1 REDLINE REVISION NO. 1 JULY 2012
TEDD APPROVAL 7/20/12
SHA NO. XX4395185

MD 355 (FREDERICK ROAD)
AT MIDDLEBROOK ROAD
GERMANTOWN, MD

TRAFFIC SIGNALIZATION PLAN SHEET

TS NO. 2283G DRAWING SG- 01 OF 04 SHEET NO. 01 OF 04

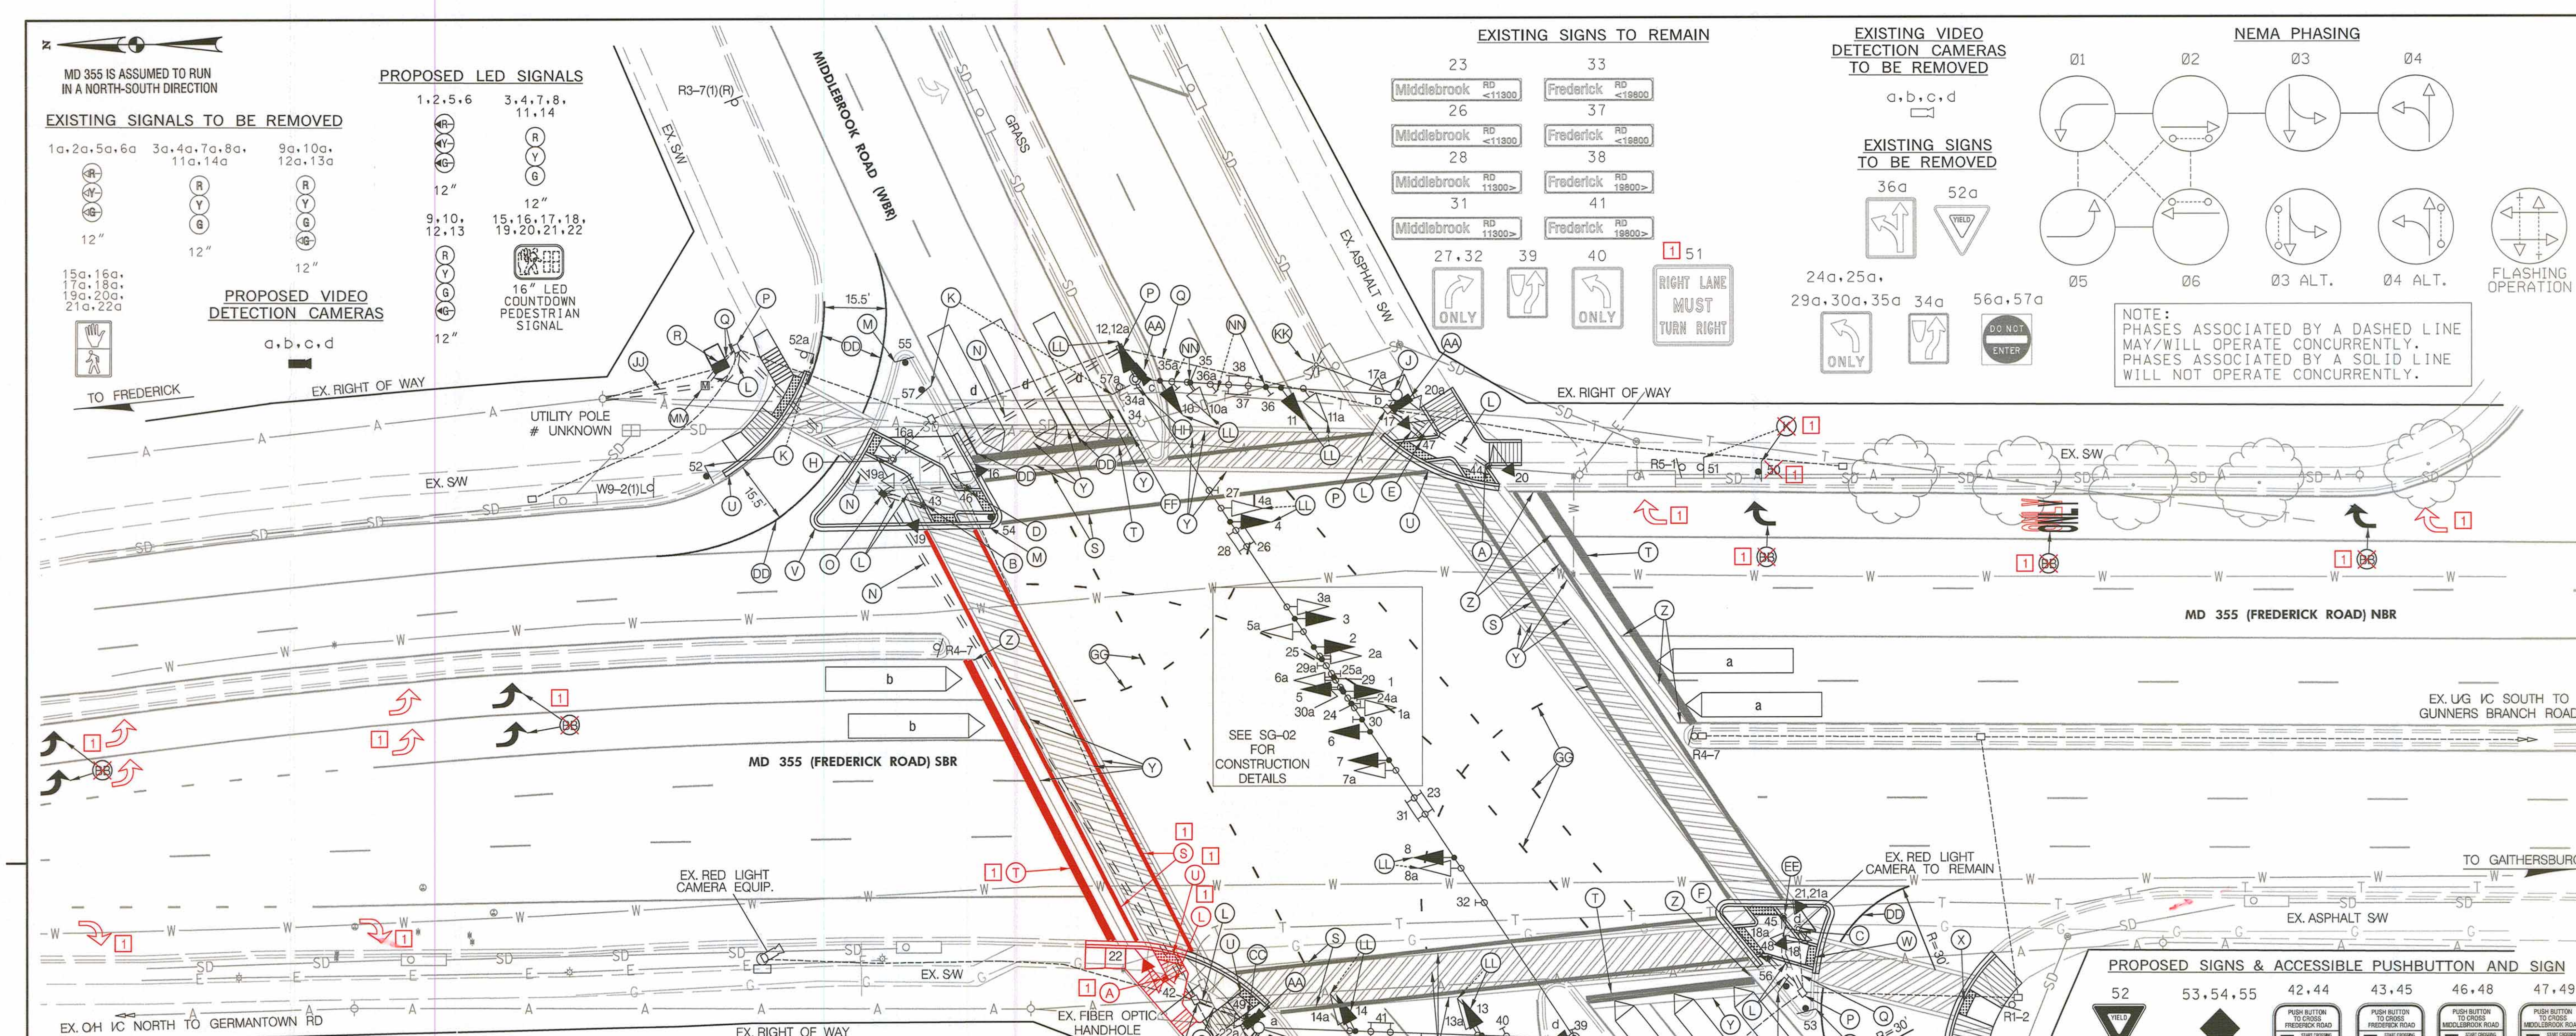
Y. REMOVE EXISTING PAVEMENT MARKINGS.
Z. REMOVE EXISTING PAVEMENT MARKINGS BETWEEN PROPOSED STOPLINE AND CROSSWALK.
AA. REMOVE EXISTING VIDEO DETECTION CAMERA AND INSTALL NEW VIDEO DETECTION CAMERA. (SEE NOTE 22).
1 ~~BB. SEE SG-04 FOR PAVEMENT MARKING SYMBOL AND LEGEND INSTALLATION DETAIL.~~
CC. INSTALL A 5 FT. BREAKAWAY PEDESTAL POLE WITH FOUNDATION SHA STD. MD 801.01-01, BREAKAWAY COUPLINGS, ACCESSIBLE PUSHBUTTON (ARROW LEFT) AND SIGN R10-3(1) "PUSH BUTTON TO CROSS MIDDLEBROOK ROAD".
DD. INSTALL 5 IN. HEAT APPLIED WHITE PERMANENT PAVEMENT MARKING LINE.
EE. INSTALL A 5 FT. BREAKAWAY PEDESTAL POLE WITH FOUNDATION SHA STD. MD. 801.01-01, BREAKAWAY COUPLINGS, ACCESSIBLE PUSHBUTTON (ARROW LEFT) AND SIGN R10-3(1) "PUSH BUTTON TO CROSS FREDERICK ROAD" (NOTE: 1-2 IN. 90 DEGREE PVC BEND).
FF. INSTALL 5 IN. HEAT APPLIED YELLOW PERMANENT PAVEMENT MARKING LINE.
GG. INSTALL 5 IN. HEAT APPLIED WHITE PERMANENT PAVEMENT MARKING LANE EXTENSION LINES (3' STRIPE - 3' GAP - 3' STRIPE).

Sign no.	Sign	Size
24, 25, 29, 30, 35	R3-5L	(36"x30")
34	R4-7	(24"x30") @ 15°
36	R3-6L	(36"x30")
1 ~~50~~	~~R3-7(R)~~	~~(30"x30")~~

24. SEE GENERAL INFORMATION SHEET FOR PROPOSED ACCESSIBLE PUSHBUTTONS AND SIGNS.
1 25. SEE SG-04 FOR PAVEMENT MARKING SYMBOL AND LEGEND INSTALLATION DETAIL.
